BARNSELY HOSPITAL NHS
FOUNDATION TRUST

MODULAR MRI

EXISTING AND PROPOSED
COURTYARD SECTIONS

(0-100)02

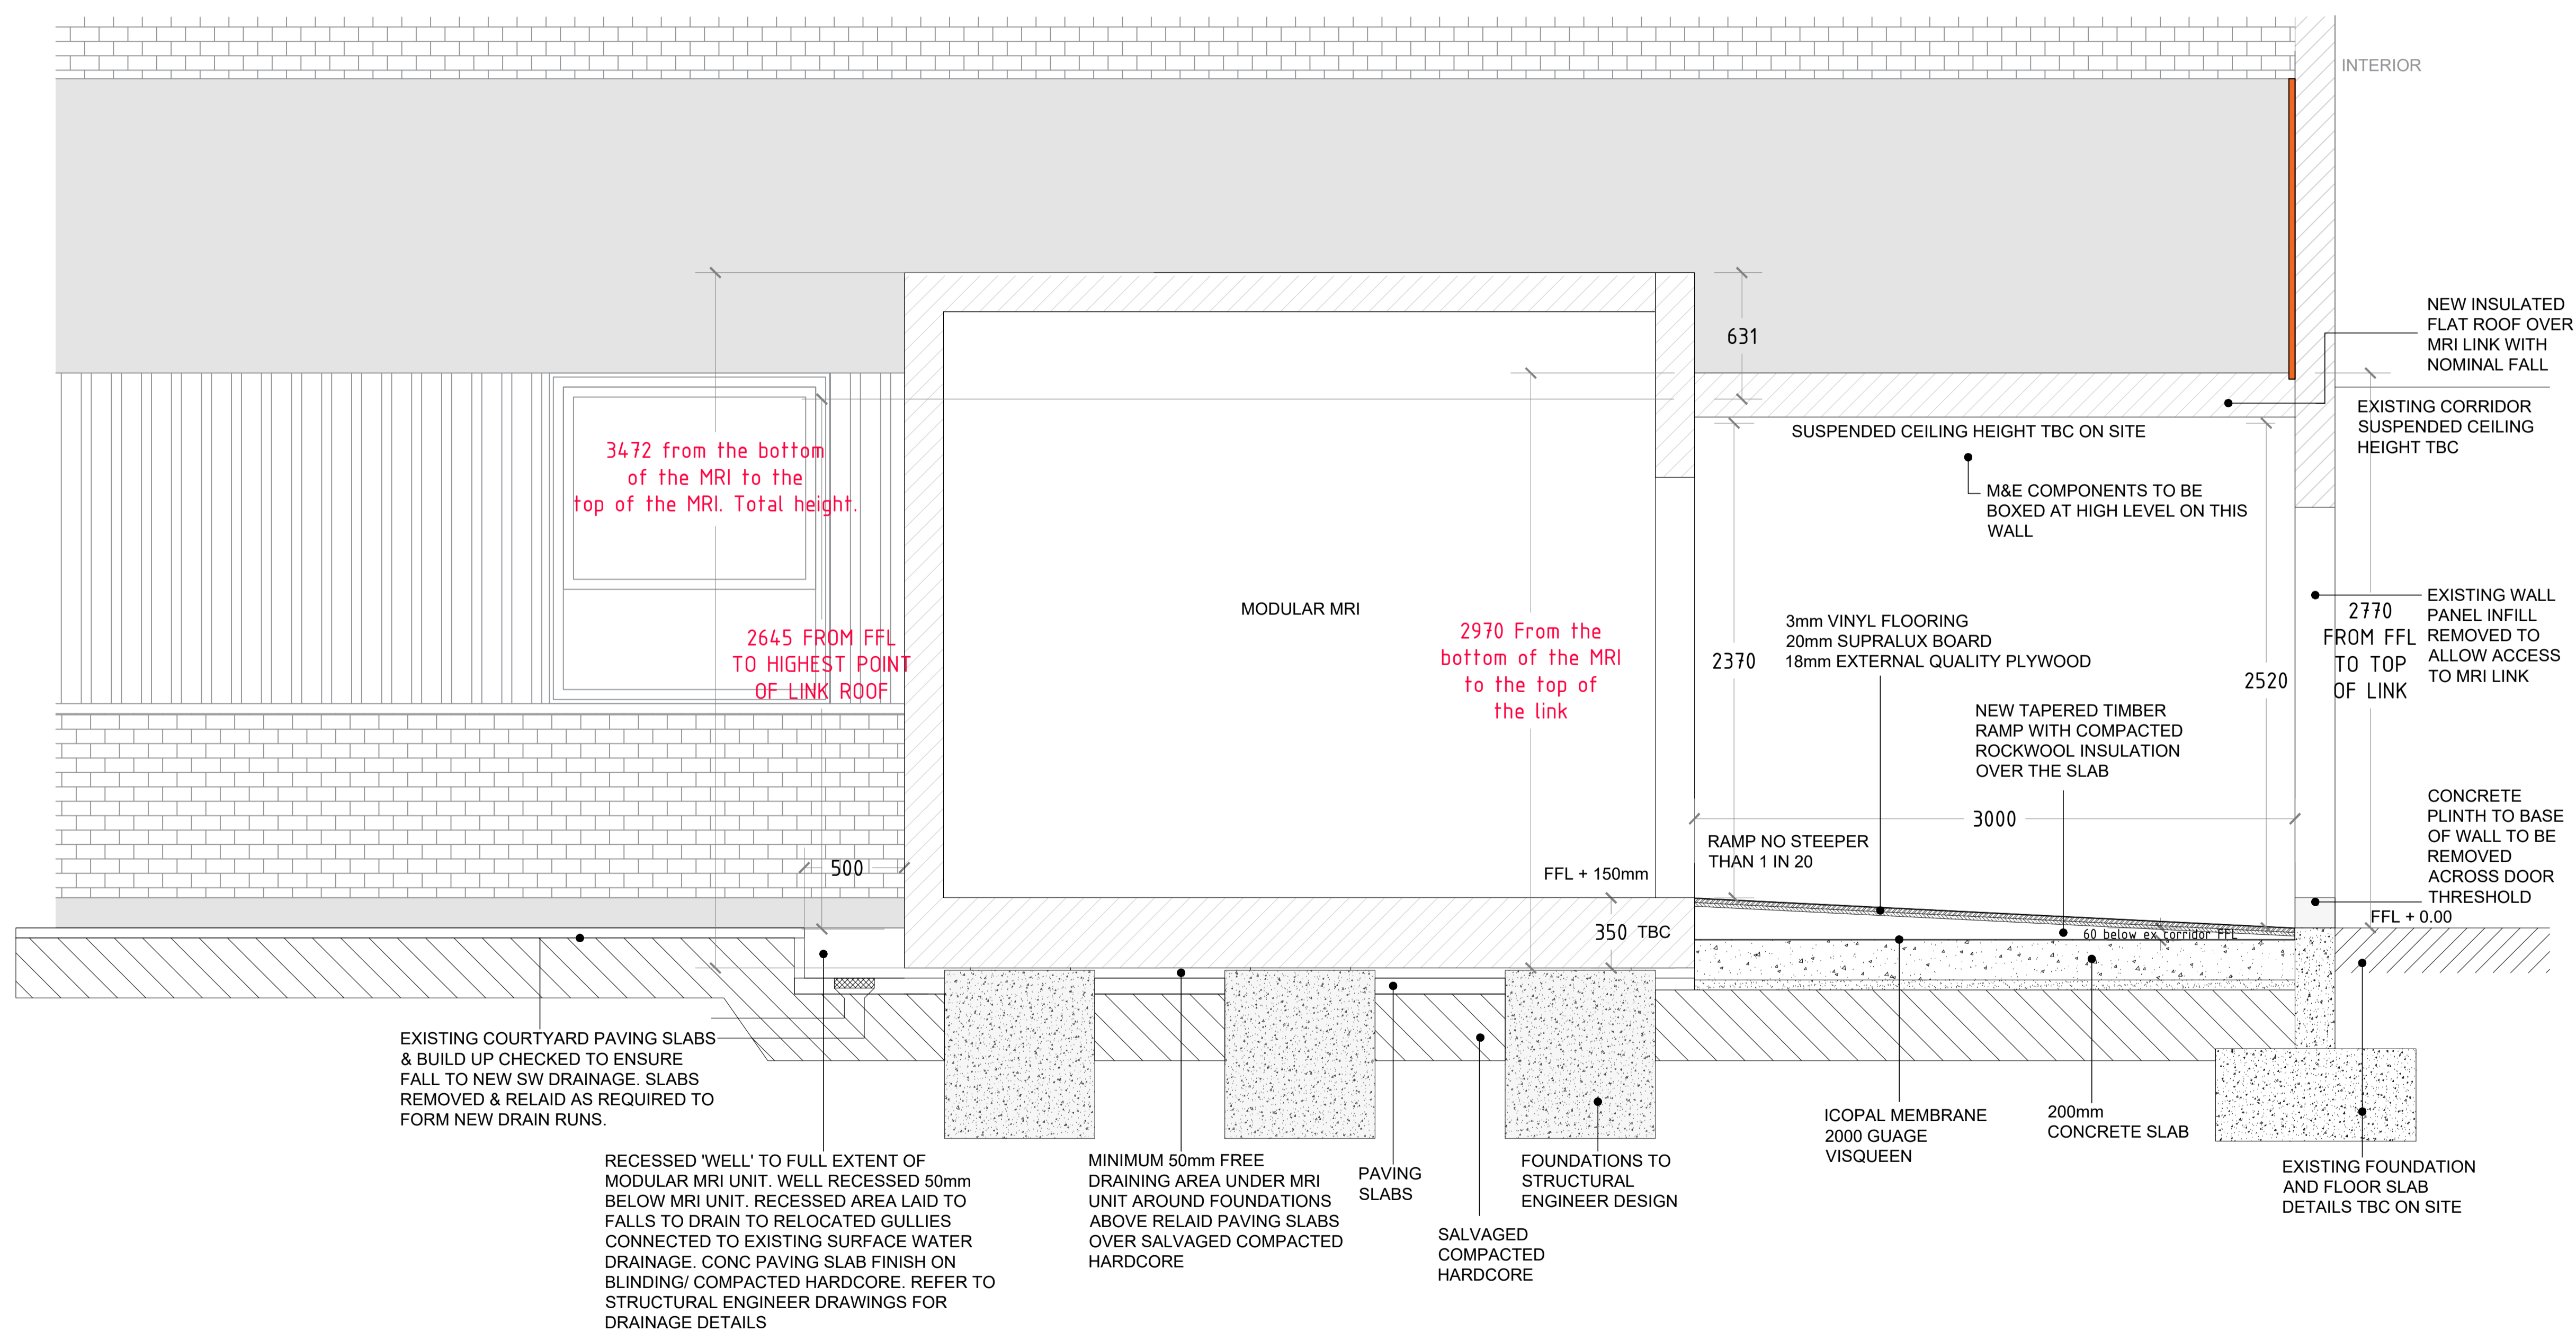
Drawn by	DB	Size	A1	Scale	VAR
Notes				Status	Rev Date
PRELIMINARY STUDY				P	-
AMENDMENTS:				P	A
- Well size reduced from 600mm to 500mm					
AMENDMENTS:				P	B 03/03/21
Ramp length and construction amended; modular building pushed further 200mm from the face of the existing building.					
AMENDMENTS:				P	C 08/03/21
Ramp base & annotation amended					
AMENDMENTS:				P	D 22/03/21
MRI and link dims added. Suspended ceiling dim amended.					
AMENDMENTS:				P	E 01/04/21
Link Heights amended following site visit.					
AMENDMENTS:				P	F 15/04/21
Link Heights amended. Suspended ceiling omitted.					
AMENDMENTS:				P	G 25/05/21
The link roof is now higher. Suspended ceiling has been reintroduced. ceiling height tbc on site.
